MVP Variance Request Form

Variance Request No.:	A-47
Date Approval Requested by Contractor:	2/10/2019
Date Submitted by Chief Inspector to LEI:	2/12/2019
Date Received by FERC:	
FERC Approval Reference No.:

Mountain Valley Pipeline, LLC
Mountain Valley Pipeline Project
Docket No. CP16-10-000

MOUNTAIN VALLEY PROJECT - H600 LINE GRANT DISTRICT,WETZEL CO.,W.V. STA. 292+06 TO STA. 350+06

HORZ. SCALE: 1" = 200'	
DRAWN BY: HEI(DRF)	3/11/15
DRAFTING CK:	.
ENGINEERING CK:	.
CONSTRUCTION CK:	.
ENVIRONMENTAL CK:	.
AFE/P.O.NO.:	
HEI PROJECT NO.: 14-10-052	
DRAWING NO.: PA-WEWV-H600-07	
SHEET 07 OF 329	REV. 10
DATE OF PLOT: 11/5/18 2:43 PM

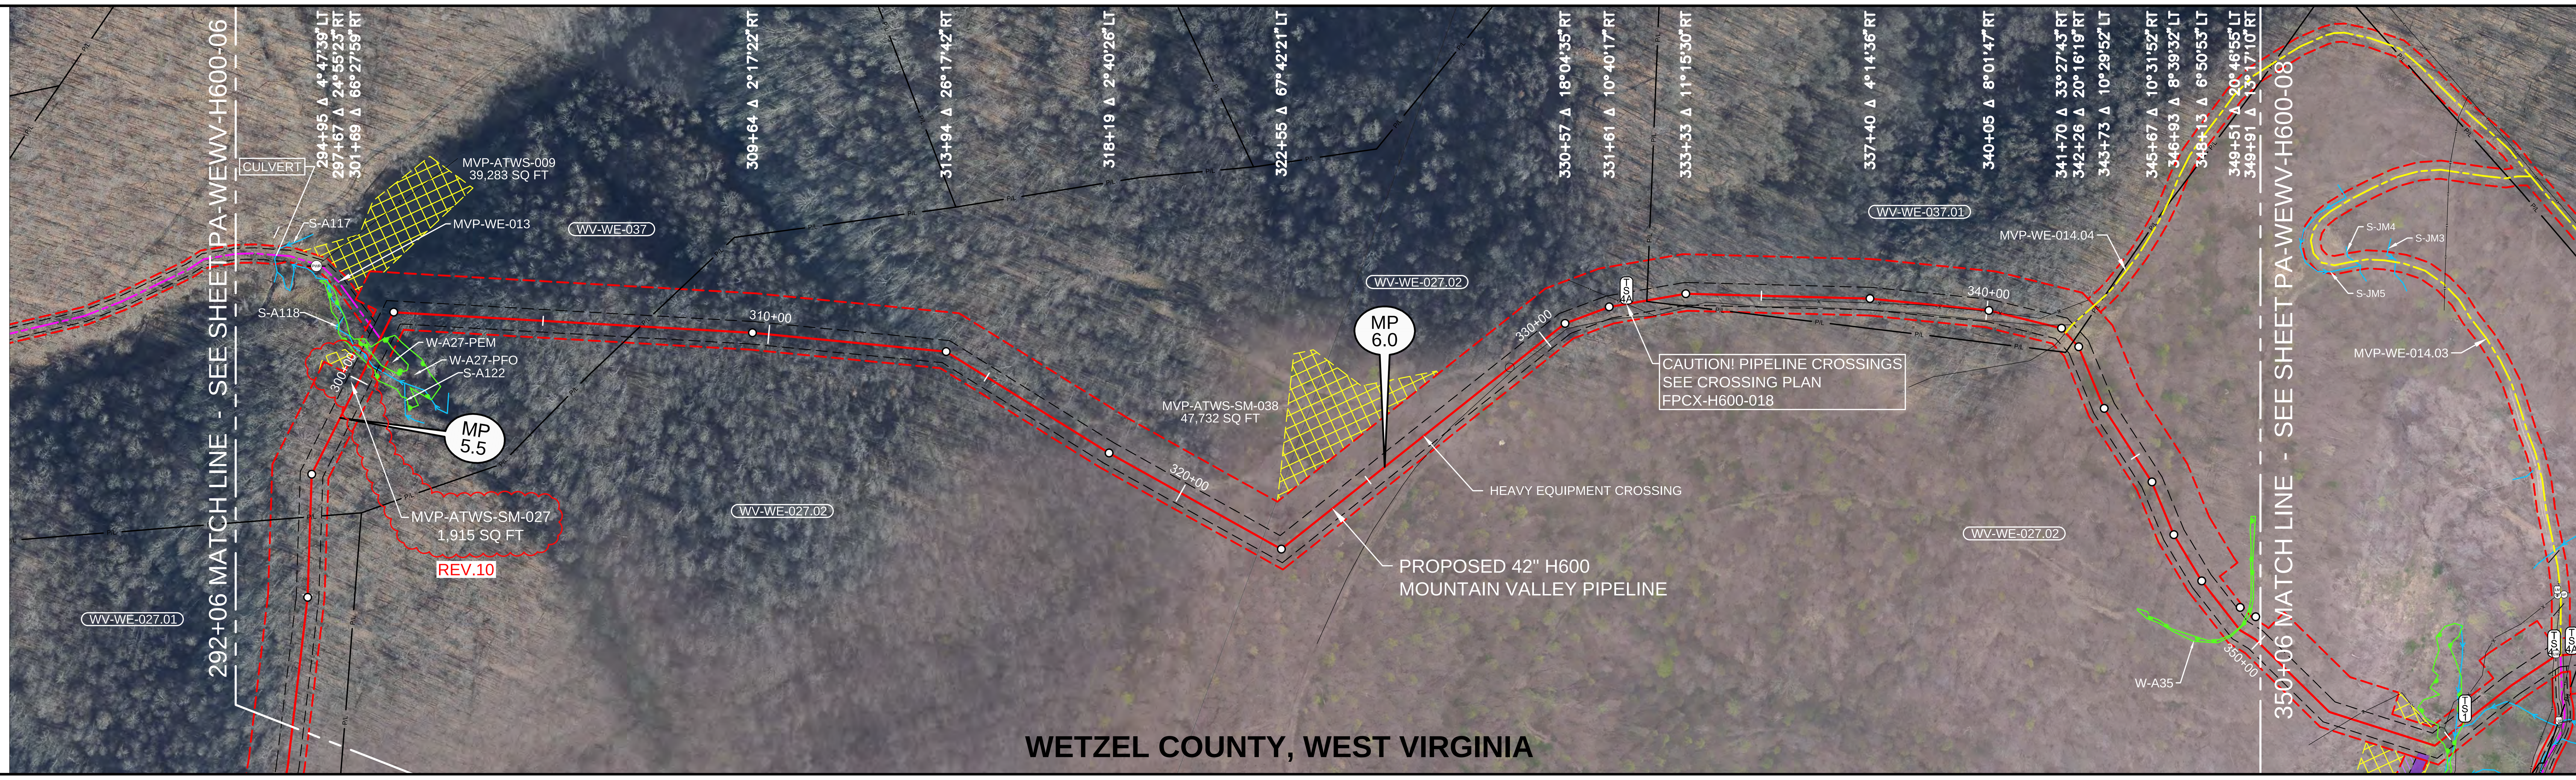
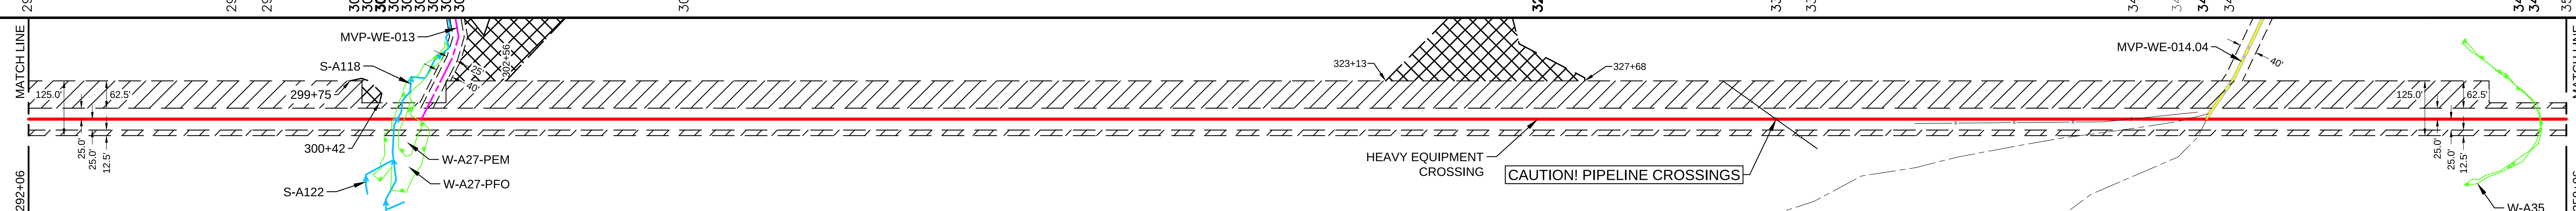
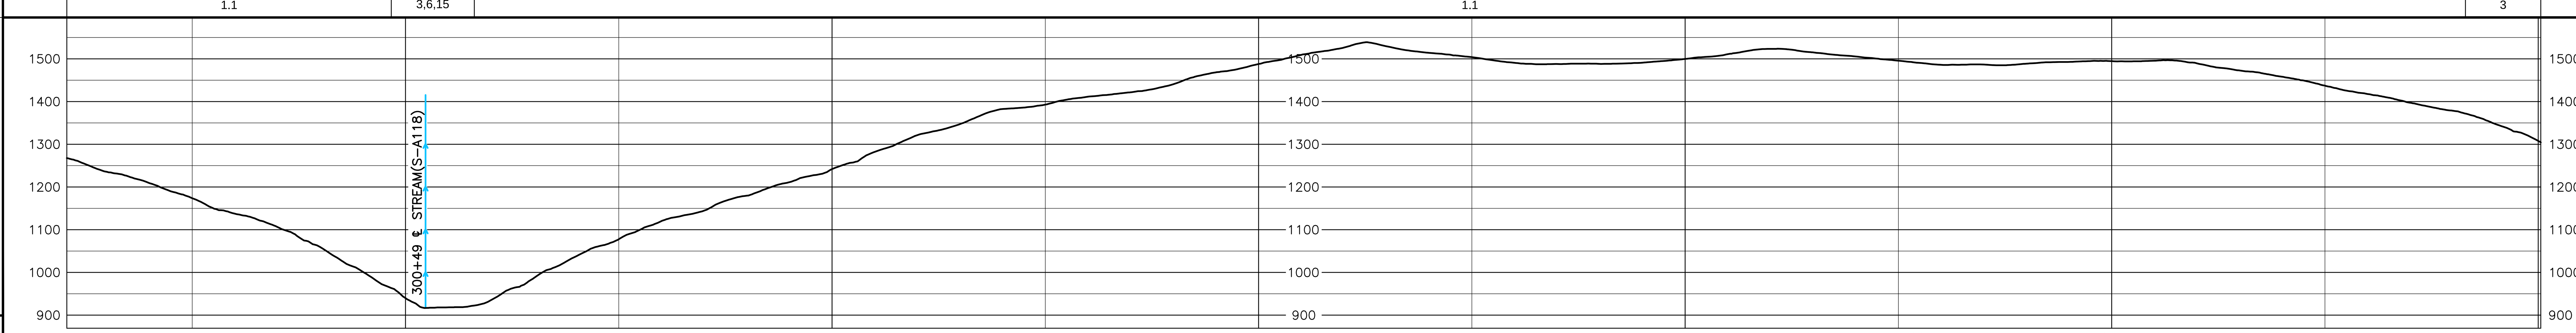
This variance adds Added MVP-ATWS-SM-027 for slip remediation. No cultural resources were found during surveys. Wetland W-A27-PEM, Wetland W-A27-PFO & Stream S-A118 were found during delineations. Wetland W-A27-PEM, Wetland W-A27-PFO & Stream S-A118 are all outside of the LOD and will incur no impacts. Resources have been avoided to the extent practicable. BMPs have been installed outside of the LOD to minimize impacts to any Environmentally Sensitive Areas within/abutting the area. This variance has a net increase of 0.04 acres of LOD from the original permit. This modification results in a new increase of 0.04 acre of tree clearing in MYSO - Known Use Summer Habitat (KUSH). On April 3, 2019, approval for Mountain Valley to cut these tress as part of a slip Emergency Endangered Species Act Consultation was filed with FERC. Attachment 2 includes a table that shows MVP's acreage "banks" will remain net positive following approval of this variance request. Resources have been avoided to the extent practicable.

Added ATWS for slip remediation.

REV.	BY	DATE	DESCRIPTION
3	HEI	09-03-16	REV. 4.1.13 ISSUED FOR BID
4	HEI	10-14-16	OCTOBER 2016 PROPOSED ROUTE - ISSUED TO FERC
5	HEI	11-11-16	REMOVE EQUATIONS
6	HEI	11-27-17	ISSUED FOR CONSTRUCTION
7	HEI	04-13-18	ISSUED FOR CONSTRUCTION - FERC REVISION REQUEST
8	HEI	05-03-18	ISSUED FOR VARIANCE-ADDED ACCESS RD MVP-WE-014.03&.04
9	HEI	11-05-18	ISSUED FOR VARIANCE - ADDED MVP-ATWS-SM-038 FOR SLIP MITIGATION
10	HEI	11-06-18	ISSUED FOR VARIANCE - ADDED MVP-ATWS-SM-027 FOR SLIP MITIGATION

Mountain Valley Pipeline Variance Survey Exhibit; Variance A-47

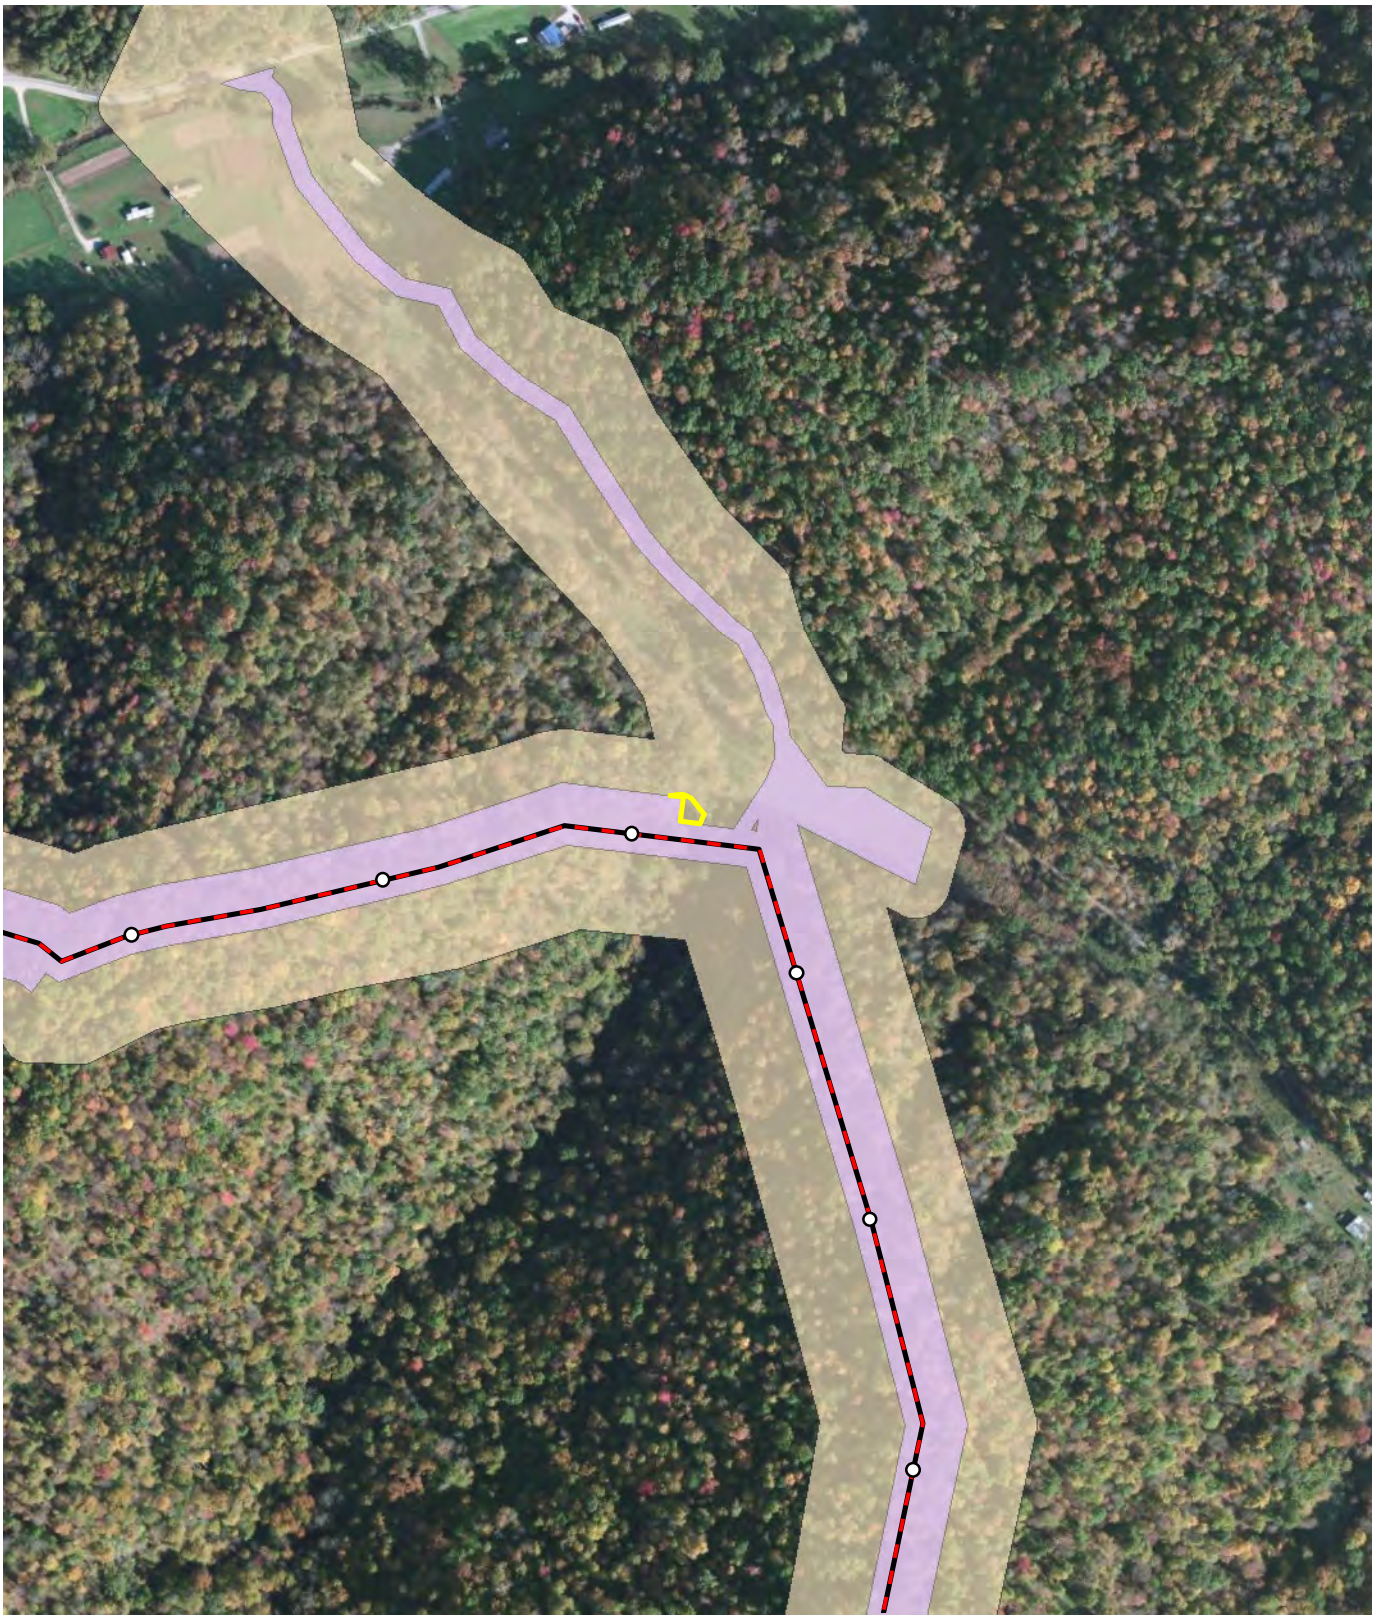
The modification of the tree clearing results in a net increase of 0.04 acres MYSO - Known Use Summer Habitat (KUSH). On April 3, 2019, approval for Mountain Valley to cut these tress as part of a slip Emergency Endangered Species Act Consultation was filed with FERC. MVP will cut the trees associated with this variance as soon as approved to do so. Attachment 2 includes a table that shows MVP's acreage "banks" will remain net positive following approval of this variance request.

On 02/12/2015, 10/27/2015, 08/15/2016 Environmental Solutions and Innovations, Inc. (ESI) conducted field surveys to search for portal openings (winter bat habitat). Surveys were conducted in accordance with agency approved protocols for the project. No portal openings were observed in the variance area.

Proposed Variance A-47

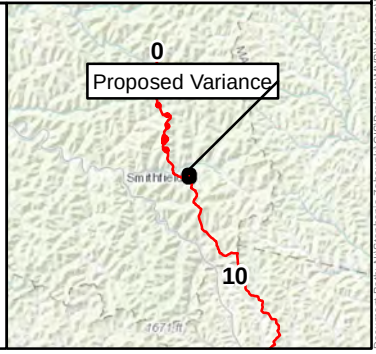
During field surveys, Tetra Tech did not identify any wetlands or streams in the variance area as shown on the attached figure.

Two wetlands and one stream were identified and delineated in the vicinity of the variance area (W-A27-PEM, W-A27-PFO, S-A118), as shown on the attached figure, but are not impacted by the variance.
